KC Lingerie Ltd. (Unit-2)

23th February 2021

Building Information

Observations

Beam layout plan

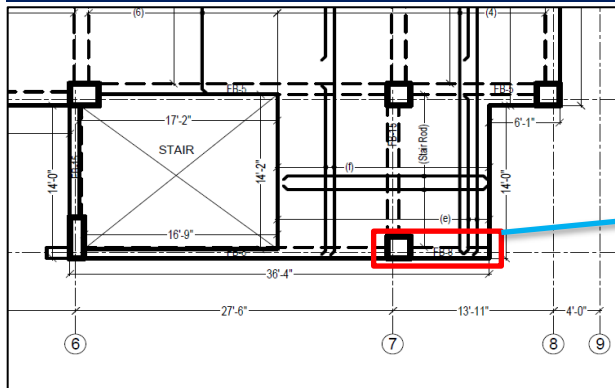
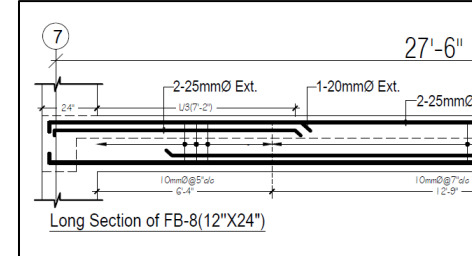
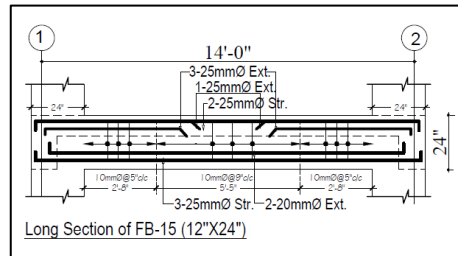
The d/s of floor beam FB-08 was found approx. 300 mm instead of 412.5 mm.

Factory engineer is required to survey the whole structure and update the as-built drawing as per on-site condition.

Sectional details of FB-15 and FB-08

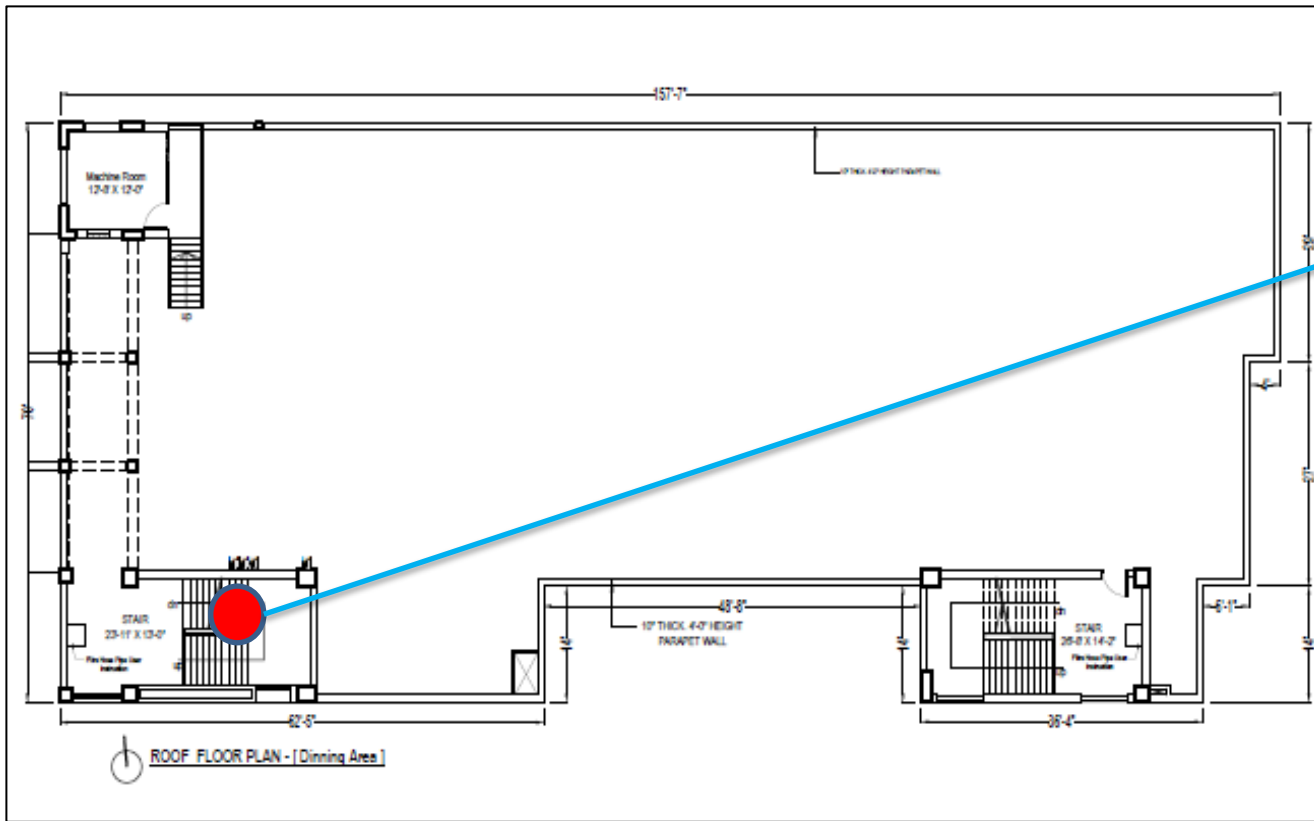
The d/s of floor beam FB-15 was found 375 mm instead of 412.5 mm.

Roof layout plan

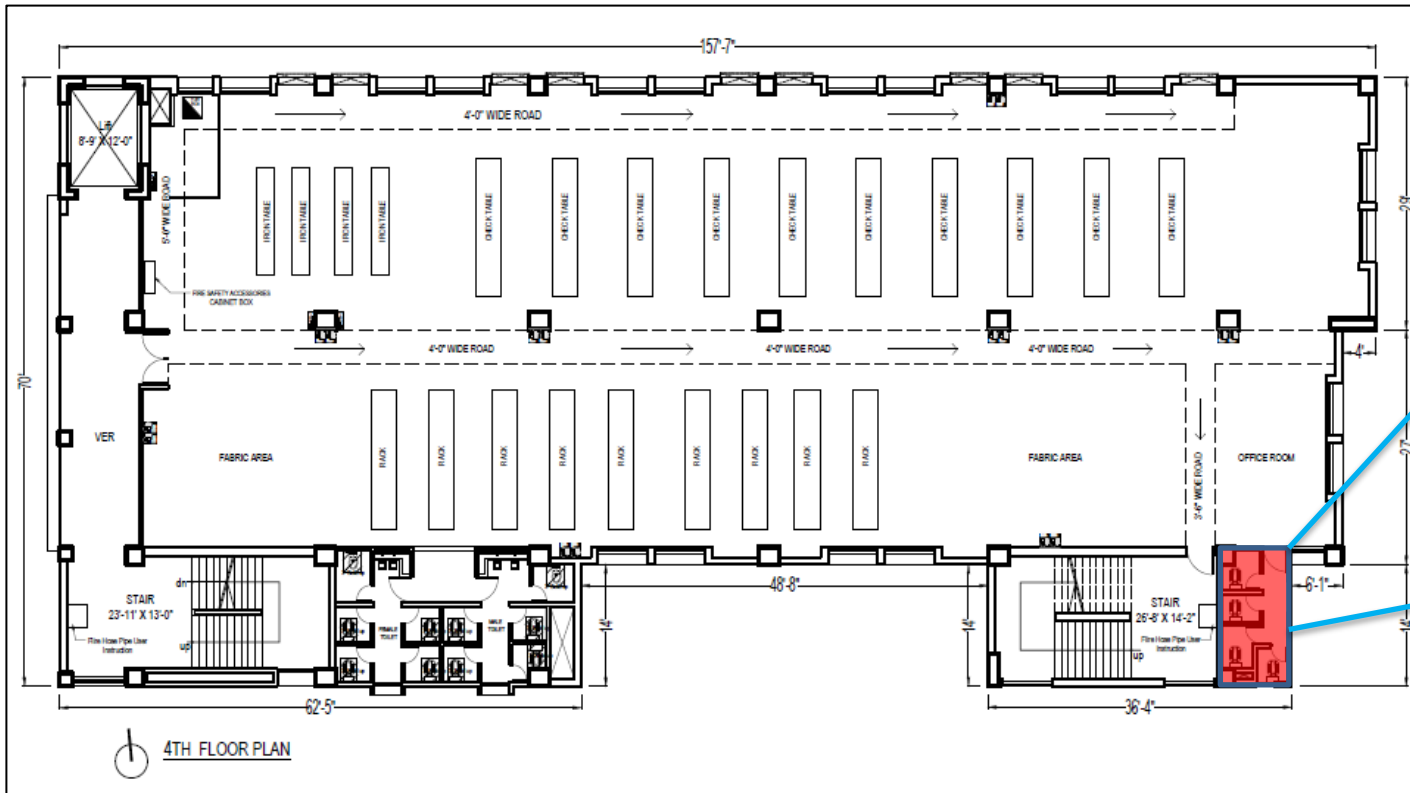
An undocumented plastic water tank (5000 liter) was found at stair roof level. No drawing was available for this water tank. Factory engineer is required to survey the whole structure and update the as-built drawing as per on-site condition.

4th floor layout plan

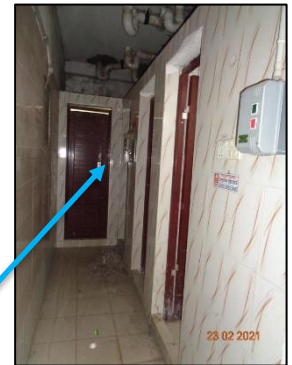
A cantilever toilet was found at south-east corner of the building from ground floor to roof. Factory engineer is required to check the adequacy of the slab at cantilever portion.

Water leakage at roof & stair roof

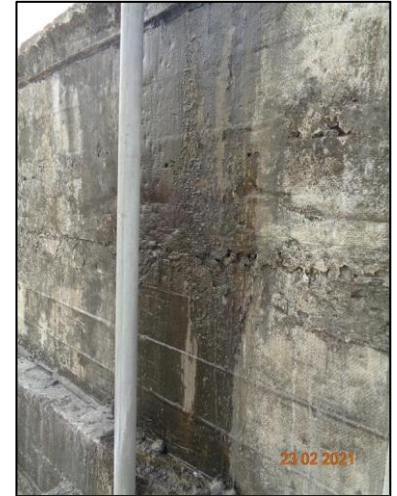
Due to leakage in the water supply line, water clogging was found at roof & stair roof. Factory engineer is required to take necessary measures to prevent the leakage in the water supply line. Also investigate the reason of leakage to verify if any damaged occurred due to the presence of the moisture in structural members.

Storage rack

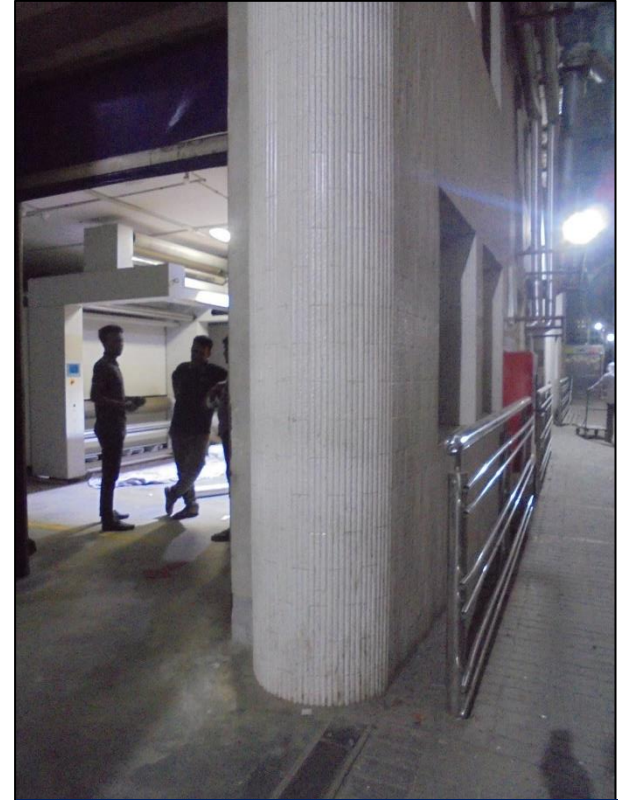
Storage racks in different floor were not anchored with floor. Factory engineer is required to anchor the storage racks with floor to avoid lateral instability.
